VILLAWOOD

LEVEL 7 PLAN

Project no. 923 Dwg #. A110

DA - ADDITIONAL INFORMATION

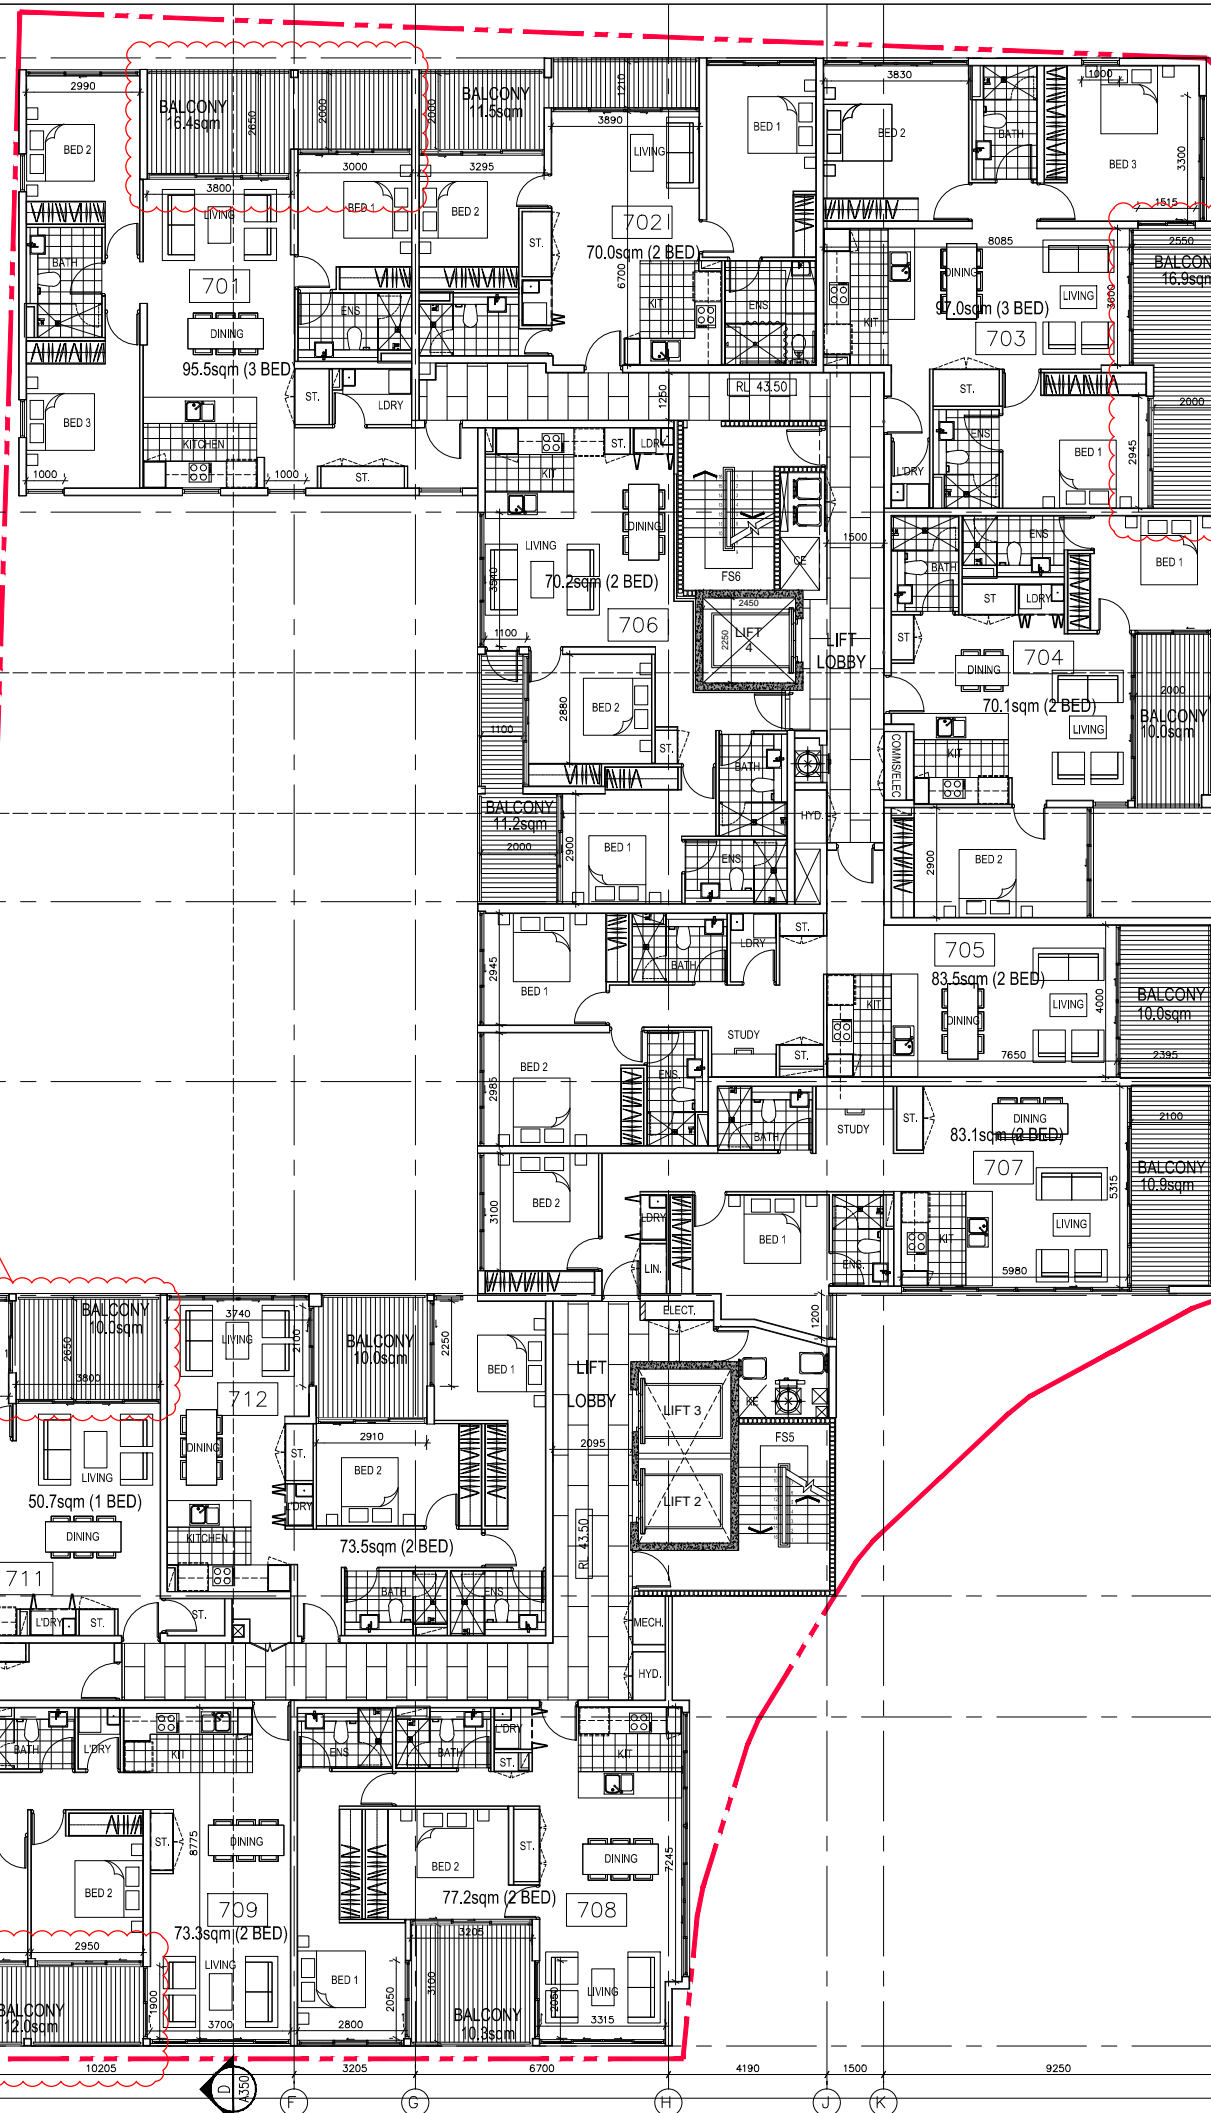
ALL OPENINGS WITHIN 3 METRES OF THE SOUTHERN BOUNDARY ARE TO BE PROTECTED IN ACCORDANCE TO BCA CLAUSE C3.4.

BALCONY DEPTH INCREASED TO ≥2 METERS IN DEPTH. (AS SHOWN IN CLOUDED AREAS)
